## Access Compliance Report Public Rights-of-Way (Curb Ramps)

Intersection ID: 13099 Main Street: E\_TRADE\_ST Cross Street: S\_MCDOWELL\_ST Location: W

ADA ID: 596EFA973FFC Ramp Type: Perp Initial Pass/Fail: Fail Overall Compliance: No Severity Score: 46.25

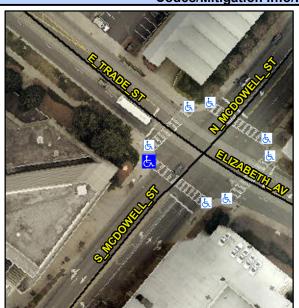
Not Found, R304.5.1, R304.2.2, R304.5.3

Field Measurements/Component Compliance					
Compliance Description		Data	Comp	oliance Description	Data
N/A	Ramp Length (in)	71.0	No	Ramp Slope (%)	10.5
No	Ramp Width (in)	45.0	No	Ramp XSlope (%)	10.0
N/A	Flare Type LT	N/A	N/A	Flare Type RT	N/A
N/A	Flare Slope LT (%)	N/A	N/A	Flare Slope RT (%)	N/A
N/A	Flare Traversable LT?	N/A	N/A	Flare Traversable RT?	N/A
N/A	Landing Length (in)	N/A	N/A	DWS Provided?	N/A
N/A	Landing Width (in)	N/A	N/A	DWS Contrast?	N/A
N/A	Landing Slope (%)	N/A	N/A	DWS Length (in)	N/A
N/A	Landing X Slope (%)	N/A	N/A	DWS Full Width?	N/A
N/A	Landing Curb? (Y/N)	N/A	N/A	DWS Offset (in)	N/A
N/A	Shared Landing?	N/A			
N/A	Gutter Ponding?	N/A	N/A	Gutter Slope (%)	N/A
N/A	Gutter Lip Ht (in)	N/A	N/A	Gutter X Slope (%)	N/A
N/A	Painted X Walk1?	Yes	N/A	Painted X Walk2?	N/A
	X Walk 1 Direction	To SE		X Walk 2 Direction	N/A
N/A	X Walk 1 Width (in)	112.0	N/A	X Walk 2 Width (in)	N/A
	X Walk 1 Slope (%)	1.3		X Walk 2 Slope (%)	N/A

Remove & Replace Entire Ramp.
